Metro South-West Joint Development Assessment Panel Agenda

8.1 Application Details: Proposed Four-Storey Mixed Use Development Fronting onto Malibu Road (38 Multiple Dwellings, 12 Short Stay Accommodation Units, Restaurant, 4 Shop/Office Tenancies, 139 Car Parking Spaces and 7 On-Street Car Parking Spaces)

Proposed Four-Storey Mixed Use Development Fronting onto Malibu Road (38 Multiple Dwellings, 12 Short Stay Accommodation Units, Restaurant, 4 Shop/Office Tenancies, 139 car parking spaces and 7 on-street car parking spaces) – Lot 1 (No.434) and Lots 1-5 on Strata Plan 11787 (No.432) Safety Bay Road, Safety Bay

Figure 6 - Extract from ground floor Master Plan (23 April 2012)

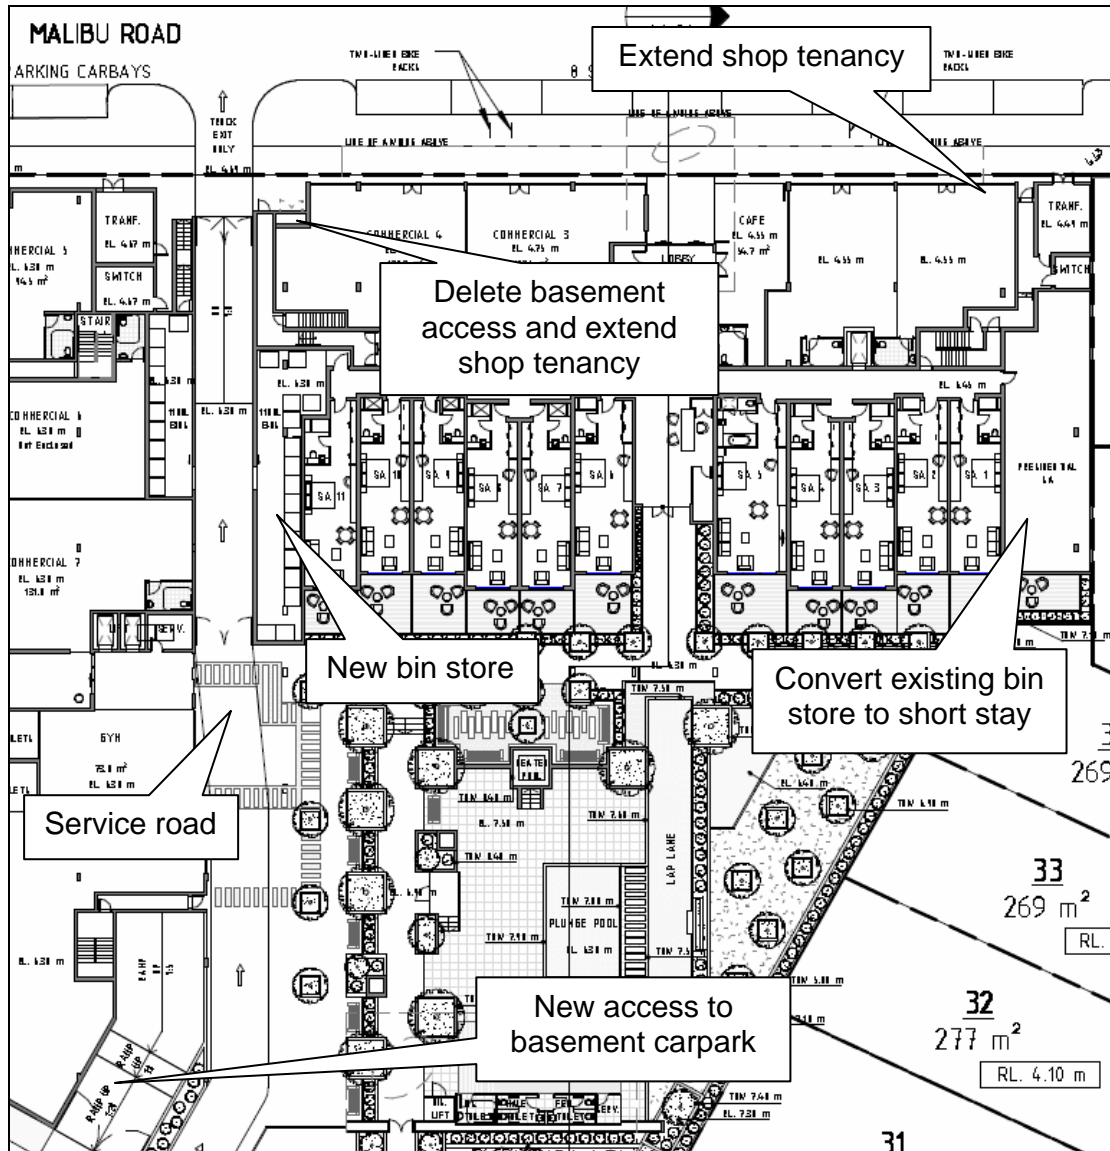
Following a meeting with City Officers in relation to concerns regarding waste disposal and access onto Malibu Road, the applicant agreed to make further modifications to the proposal by:

- b) Providing a new basement vehicle access point near the southern corner of the proposed building, and provide a connection to the existing carpark;
- c) Relocate the bin store to the south western side of the building, and include a new service road to provide vehicle access to the bin storage area;
- d) Converting the existing bin store to short stay accommodation units;
- e) Altering the size, shape and frontage of the end shop/office tenancies; and
- f) Converting the on-street waste truck space to a regular on-street car parking space.

The Master Plan shows a service road along the southwest edge of the proposed development, which would also service the adjacent future building. This service road would be partly constructed at this stage, given the level difference between the bin storage area and the existing adjacent carpark.

The changes are shown in amended basement and ground floor level Master Plan received on the 23rd April 2012, which are included as Attachment 2 and include the following ground floor plan:

The result is an outcome that provides for the collection of waste in a safe manner that does not impact on the amenity of the street. The amended Master Plan is included as Attachment 2 to this report, and an extract is included as Figure 6.
